SUPPLEMENTAL INSTRUCTION

PROJ.: **Boys and Girls Club Prince of Wales**
PROJ. No.: **1716**
DATE: **Jan 26, 2018**
S.I. No. **S.I. - 008**

Update to Structural Drawings – Phase 1

Information Bulletin S03

DRAWING
GROUND FLOOR DEMO PLAN

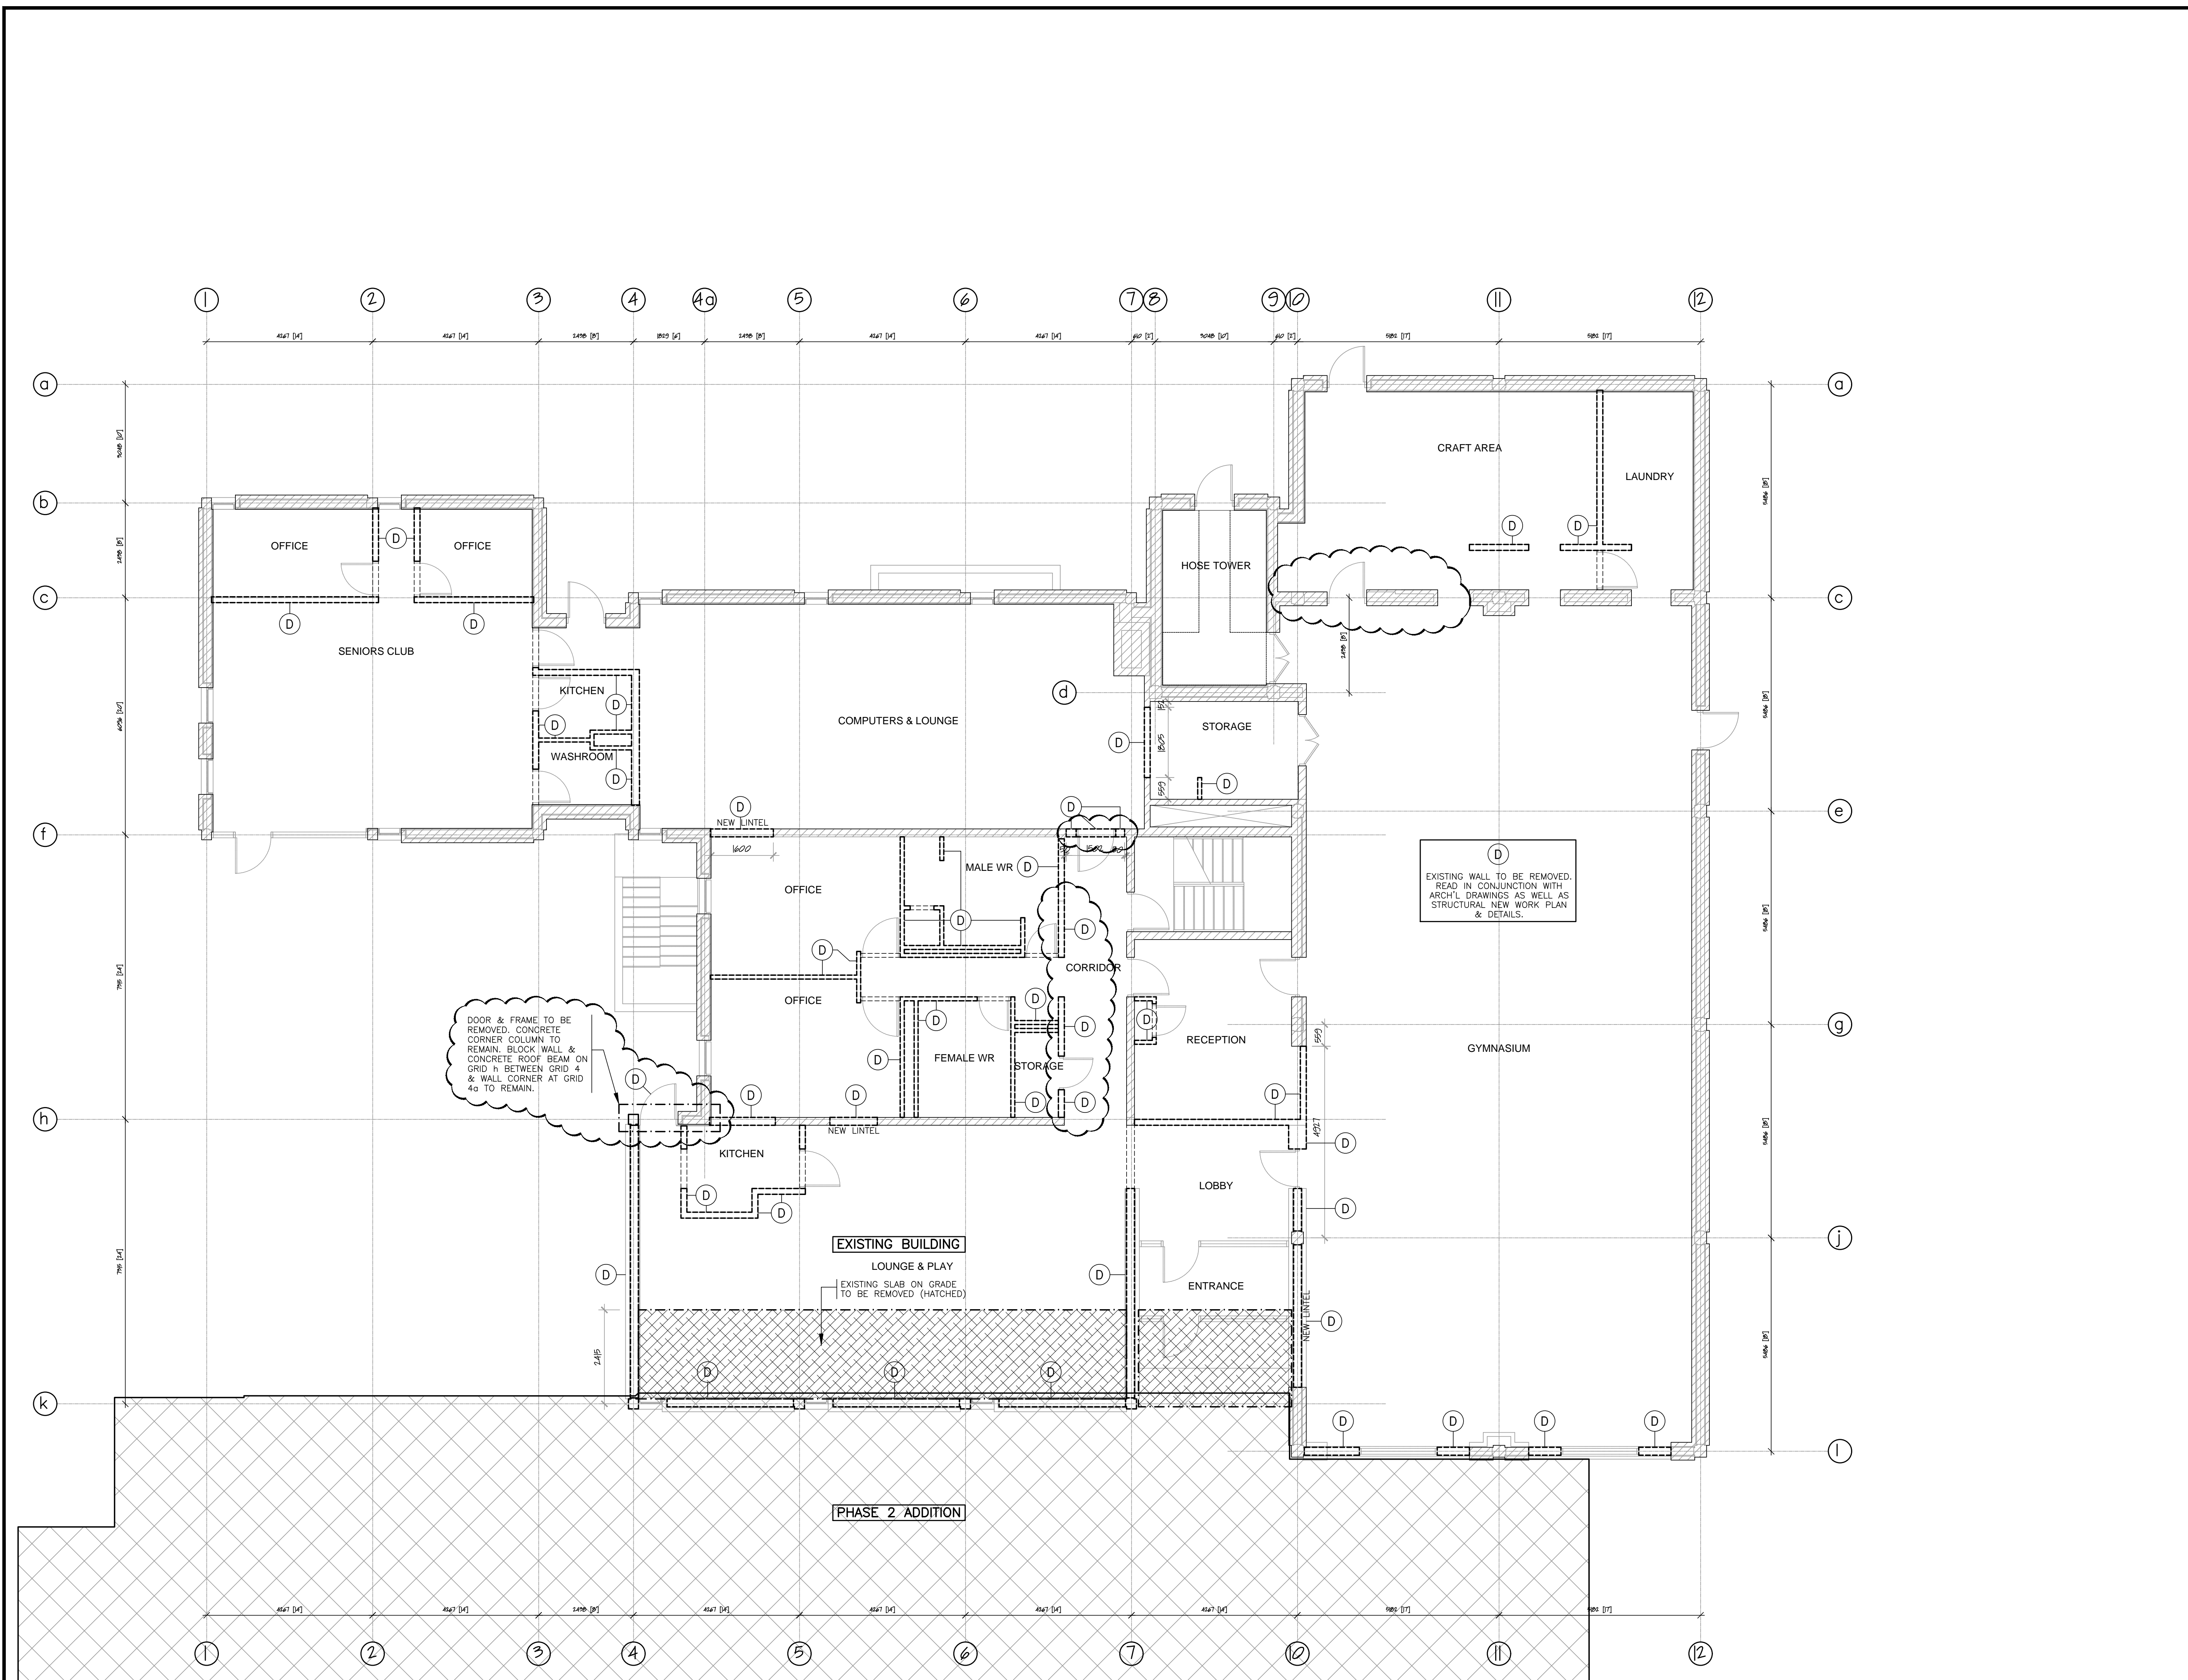
- .1 SD2 GROUND FLOOR DEMO PLAN – REVISIONS ARE CLOUDED
- .2 SD3 ROOF DEMO PLAN – REVISIONS ARE CLOUDED
- .3 SN2 GROUND FLOOR PLAN – NEW WORK – REVISIONS ARE CLOUDED
- .4 SN3 ROOF PLAN – NEW WORK – REVISIONS ARE CLOUDED
- .5 S300 SECTIONS & DETAILS – REVISIONS ARE CLOUDED
- .6 S301 SECTIONS & DETAILS – REVISIONS ARE CLOUDED

The revisions in this Information Bulletin address a construction phasing issue that separates Phase 1 into two separate phases identified as Phase 1A & 1B. It also addresses coordination items with the Architect, as well as cost saving revisions. Please read in conjunction with the Architectural drawings.
